Late Reports to Council

Subject: Late Report 1 - Uralla Local Traffic Committee

Minutes of Uralla Local Traffic Committee Held at 2.00pm on Tuesday, 05 December 2017 in Council Chambers

Option 2 – Maitland Street – King Street intersection layout

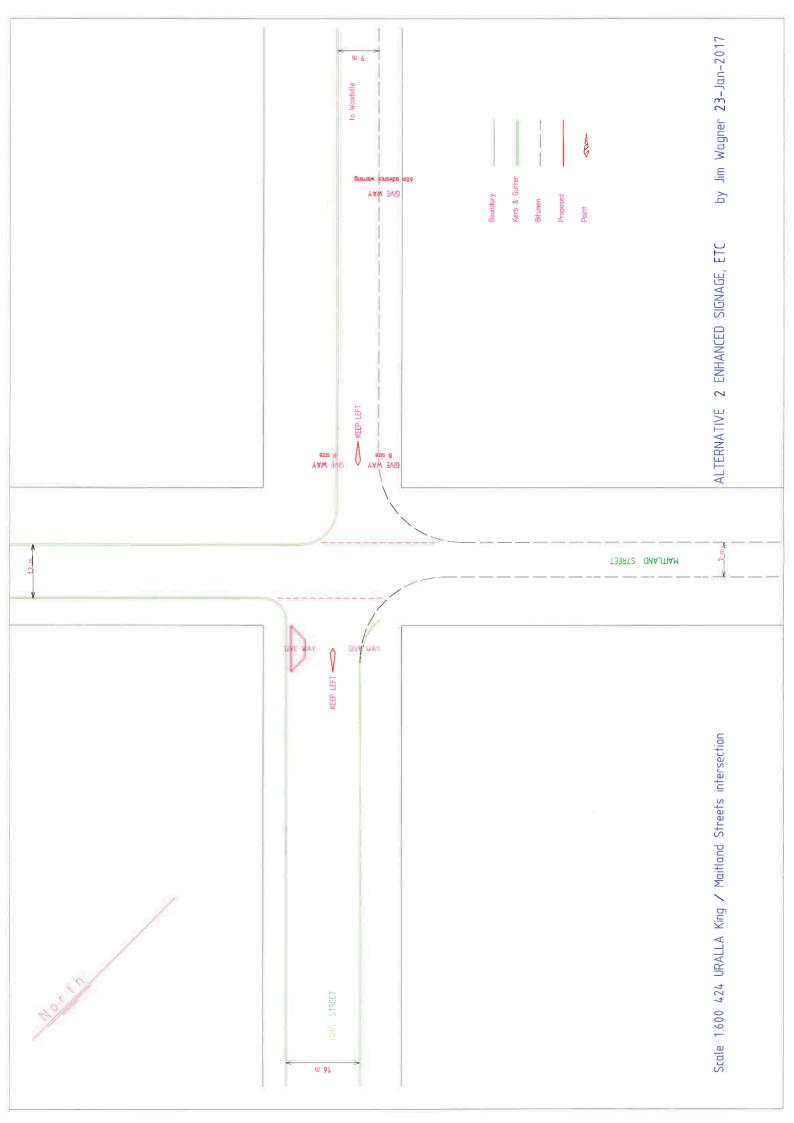
The LTC considered the options presented and selected Option 2 as the preferred option.

Four layouts were provided for the LTCs consideration.

That the treatment option 2 (attached) be implemented subject to funding approval by Council.

That the treatment option 2 (attached) be implemented subject to funding approval by Council.
